VILLAGE OF
BURR RIDGE
7660 COUNTY LINE ROAD
BURR RIDGE IL 60527

RE: January 20, 2025 Plan Commission Meeting Follow-up

Plan Commission Requested Information / Review Comments:

Development Review Comment Letter

C2

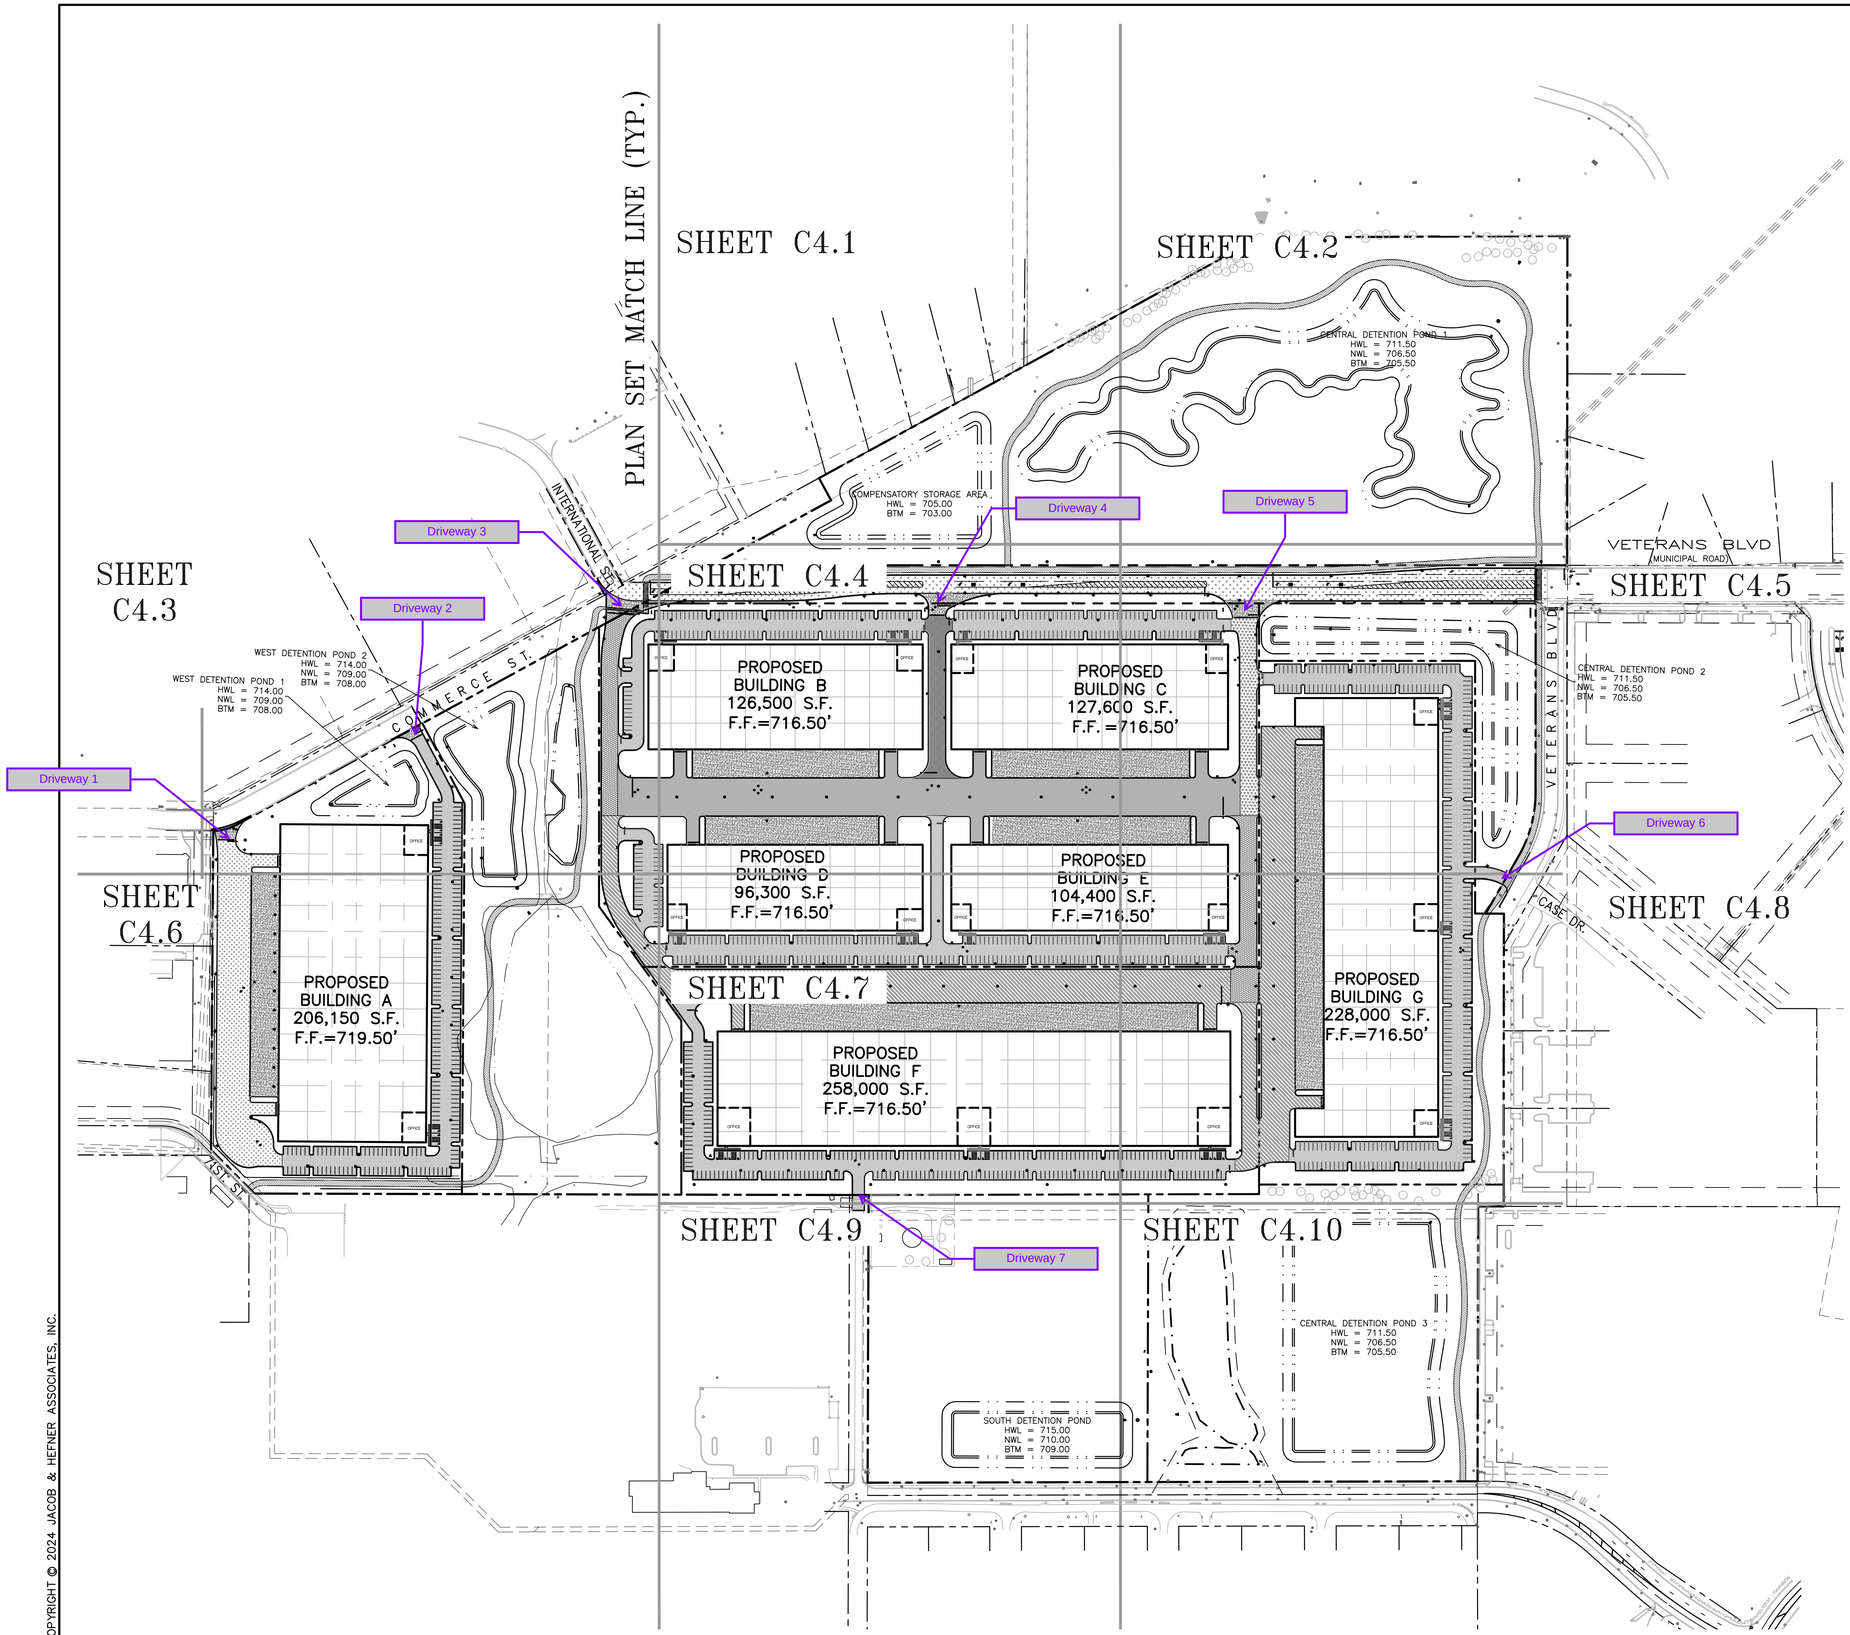
2) The width of all driveways shall be measured at the lot line adjoining a street (IV.Y.1.a). There are several driveways (see sheet C2 for markup) which exceed the maximum driveway width specified by section IV.Y.1.c.3. Driveways for non-residential uses shall be not less than 24-feet wide or more than 35 feet wide for a two-story driveway serving more than 20 parking spaces and/or two or more loading spaces. See sheets C3.3, C3.4, and C3.5.

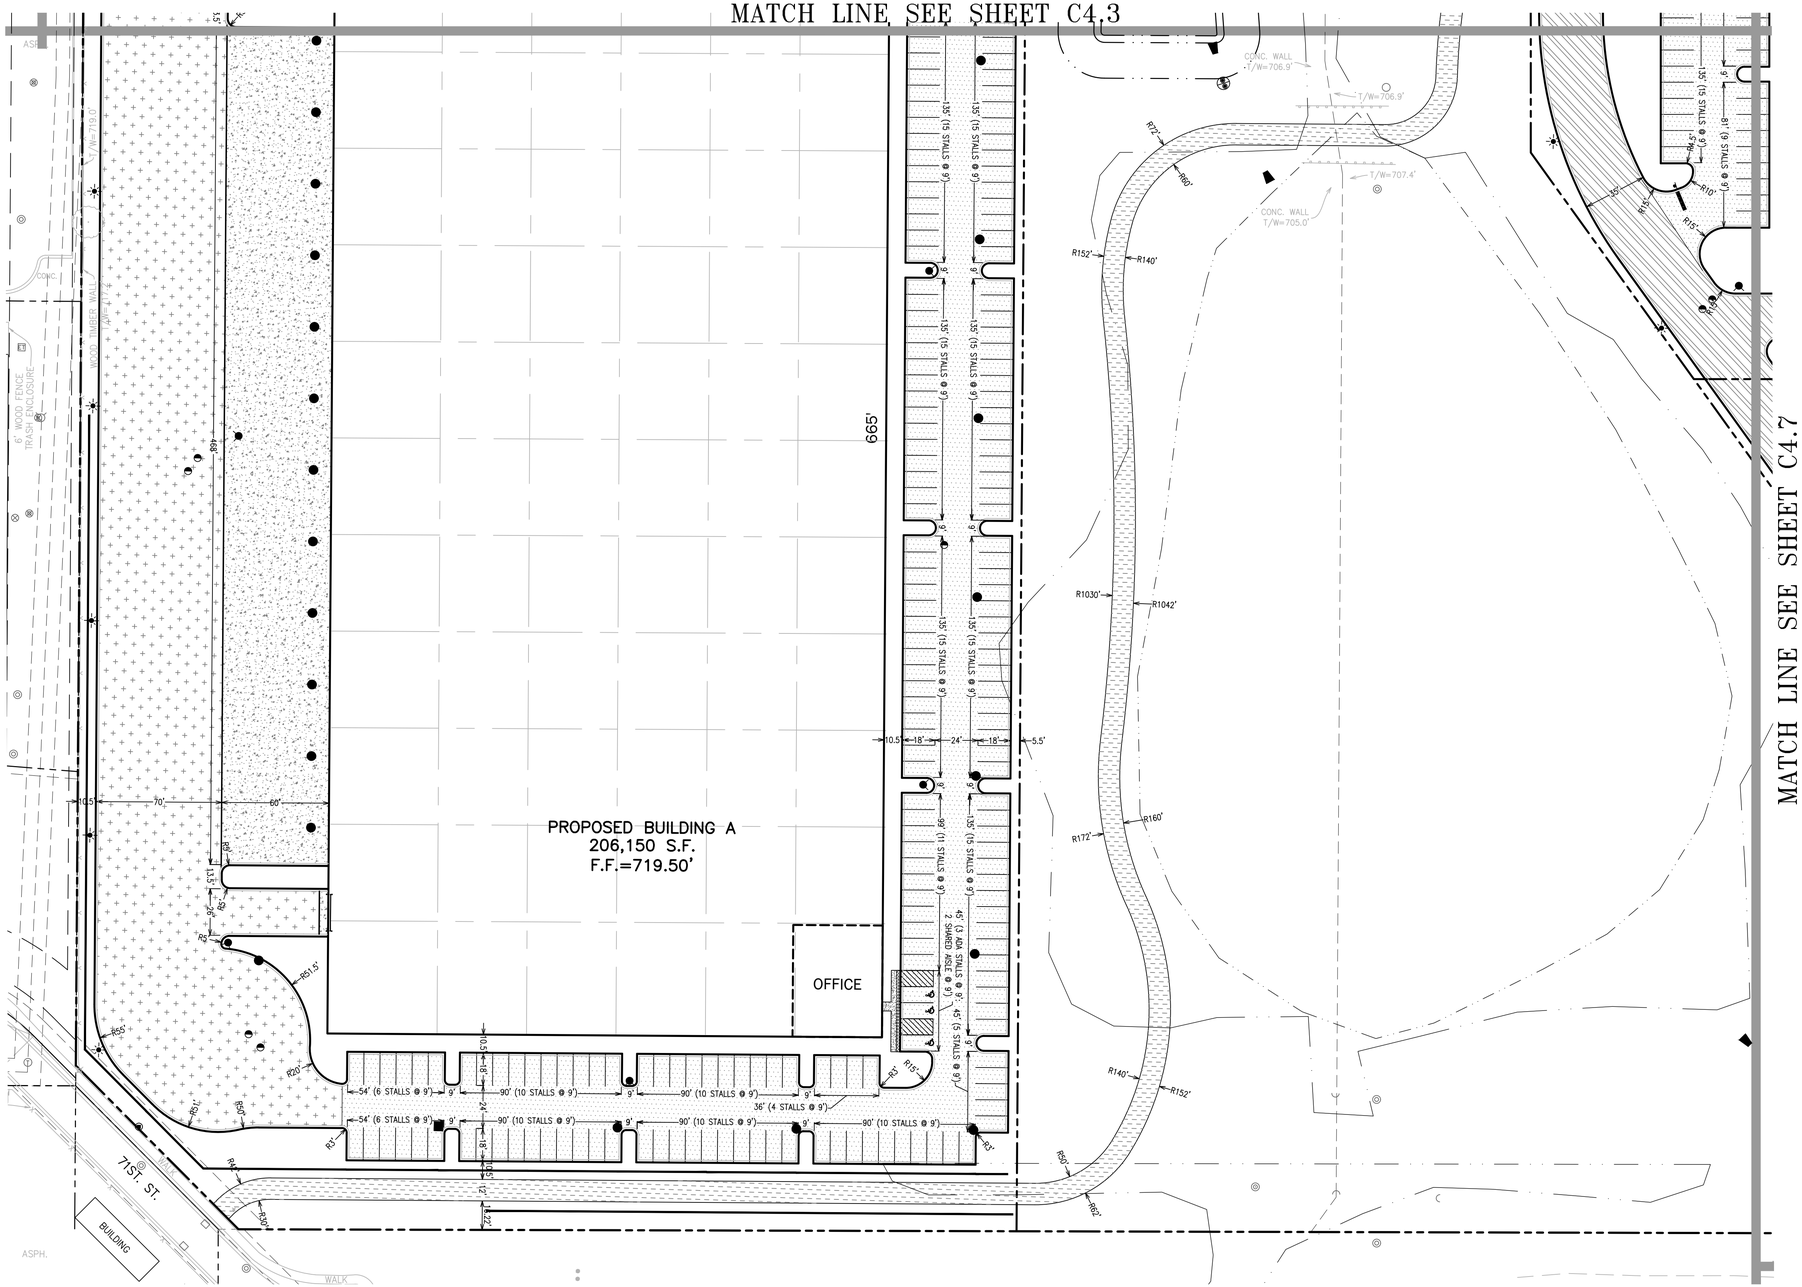
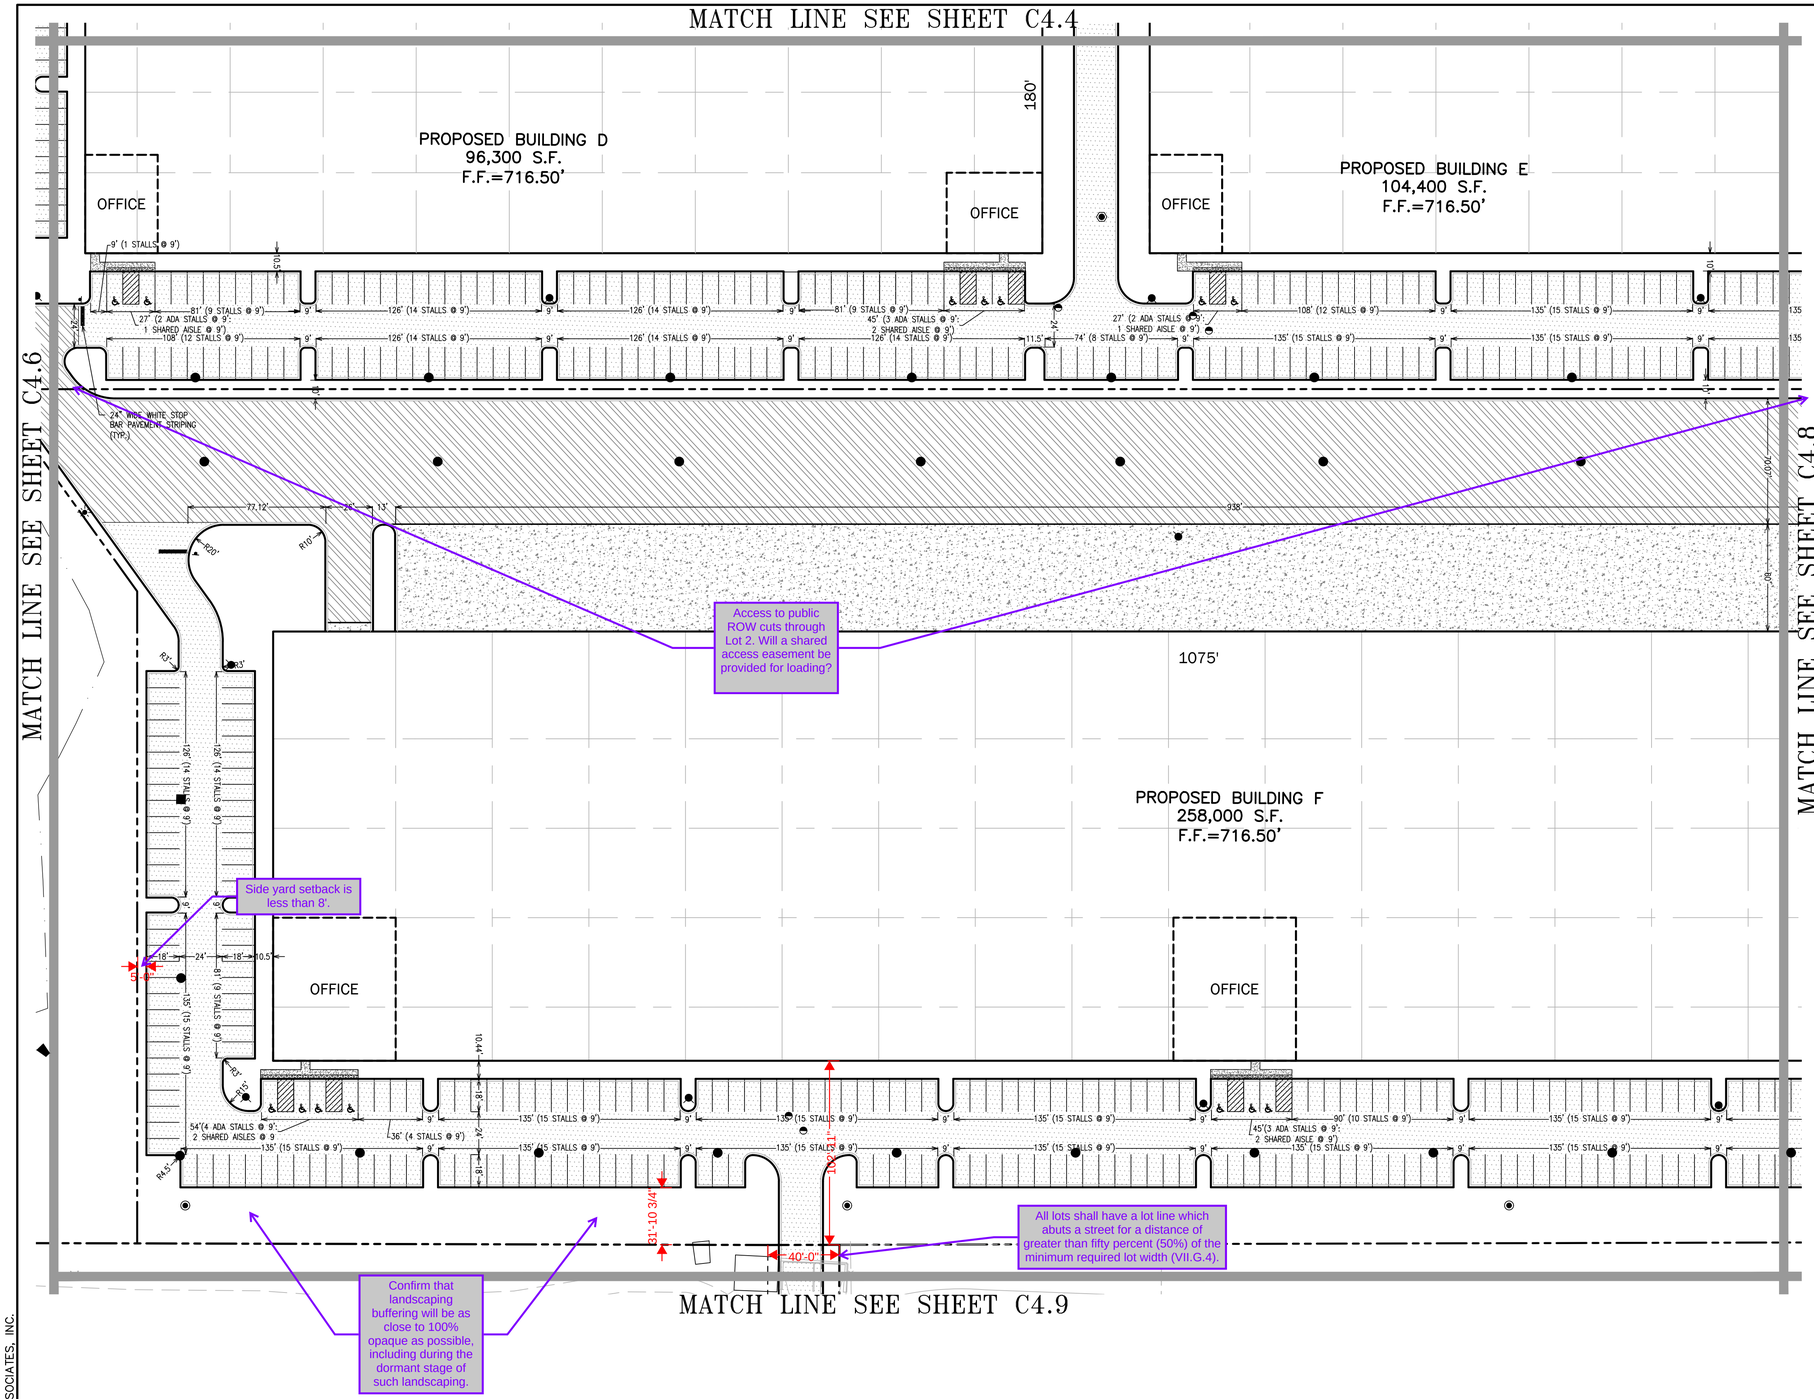
Show 4' dimension for stop line offset from crosswalk; IDOT District One detail TC-13

VETERANS BLVD. PLAN AND PROFILE
STA:1+00 - 11+00

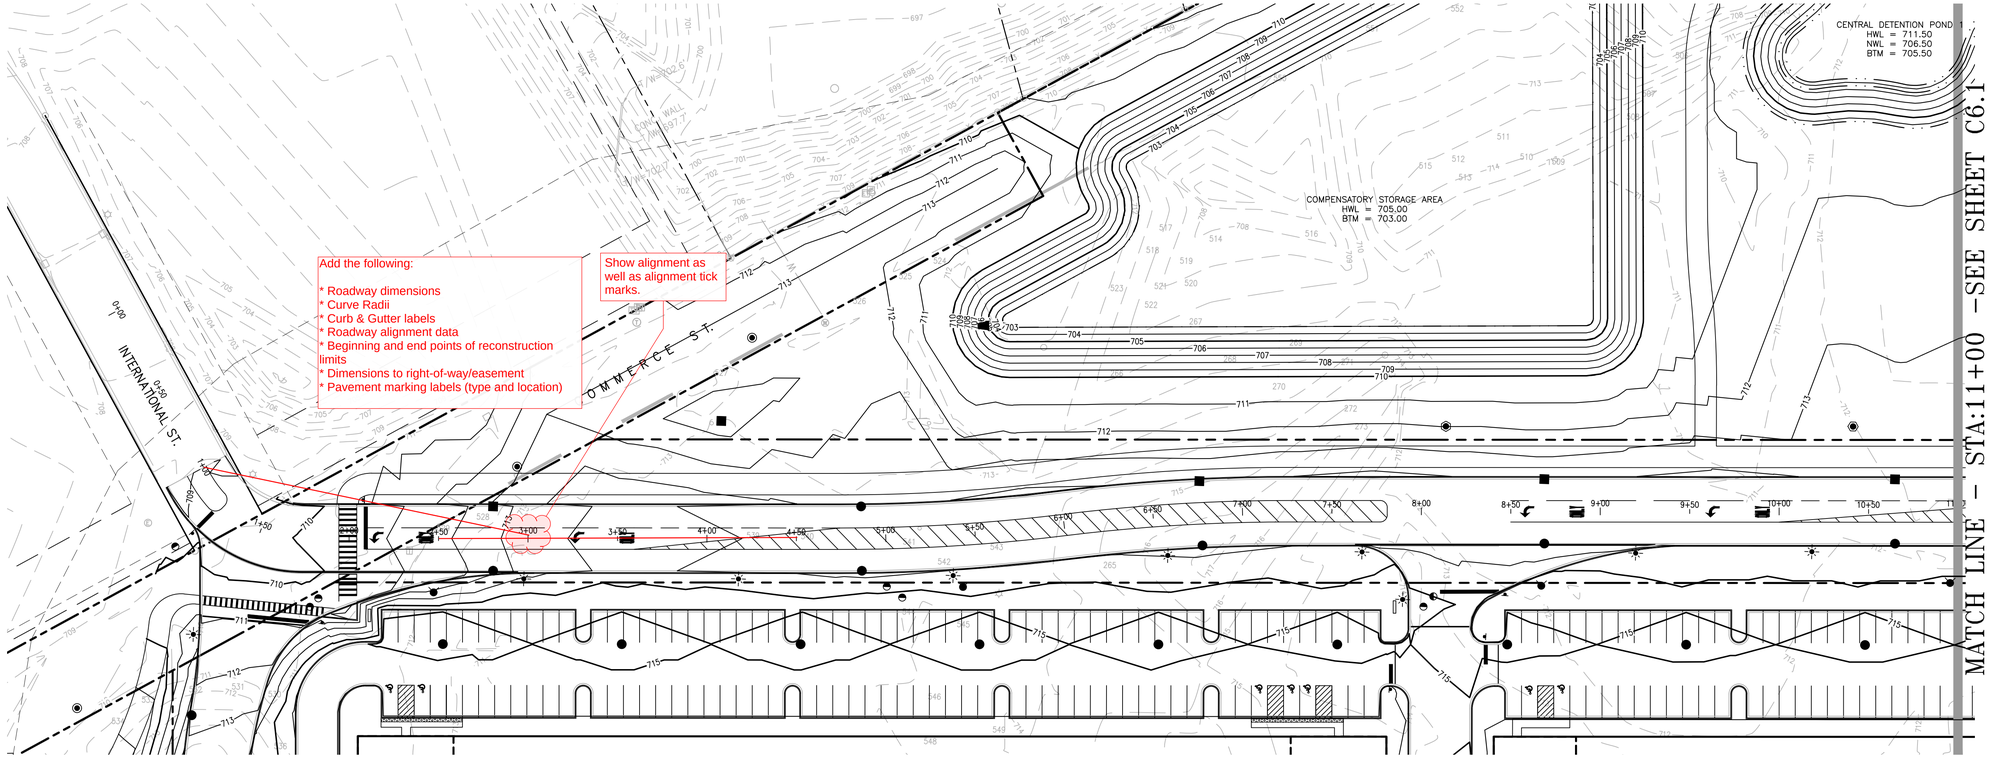
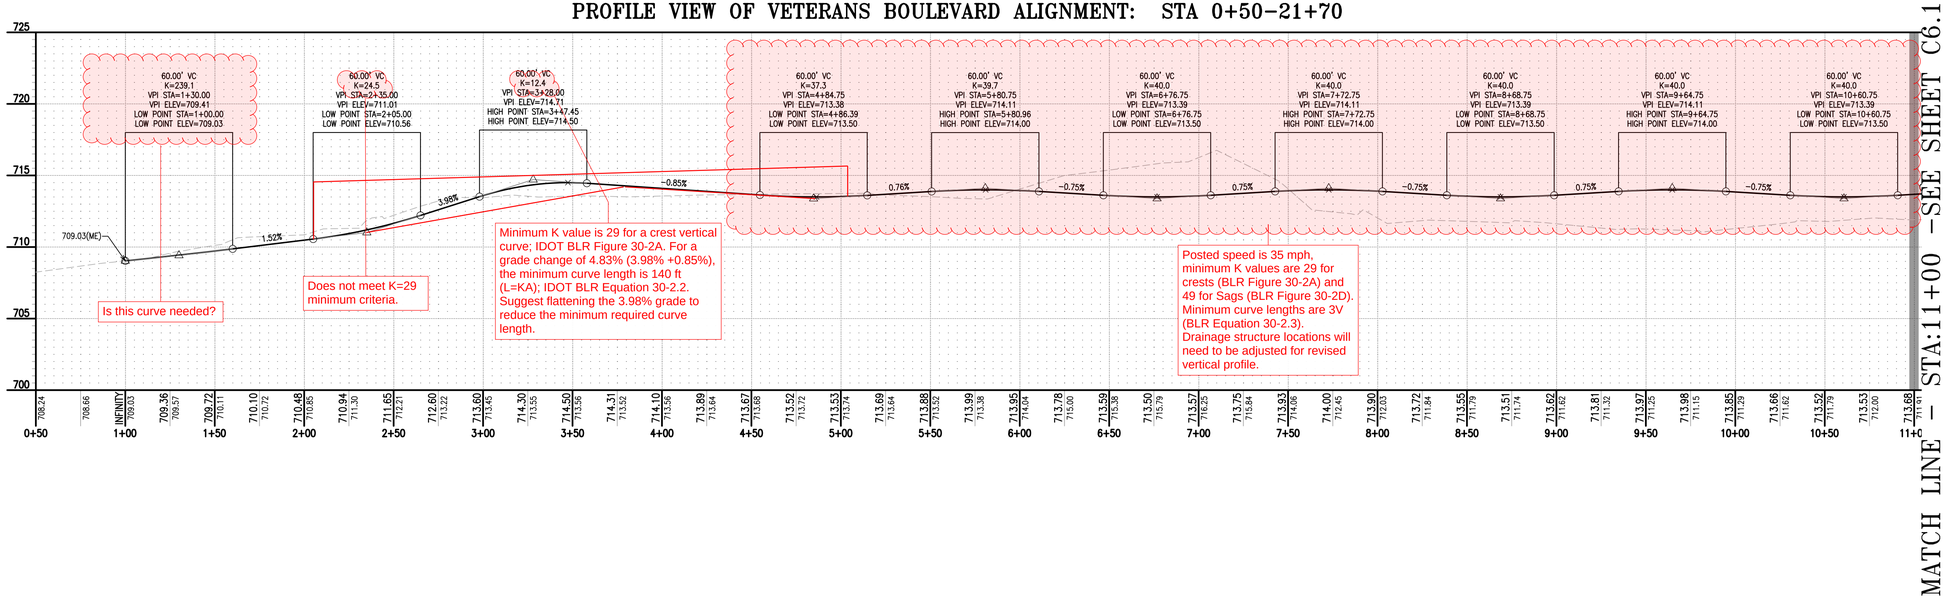
24) There is an approximately 5.5-feet grade change at the connection of Veterans Blvd with International St. Please confirm that stopping sign distances and clear view requirements are met at this curve per Burr Ridge Subdivision Ordinance section VII.D.3. See Sheet C5.0.
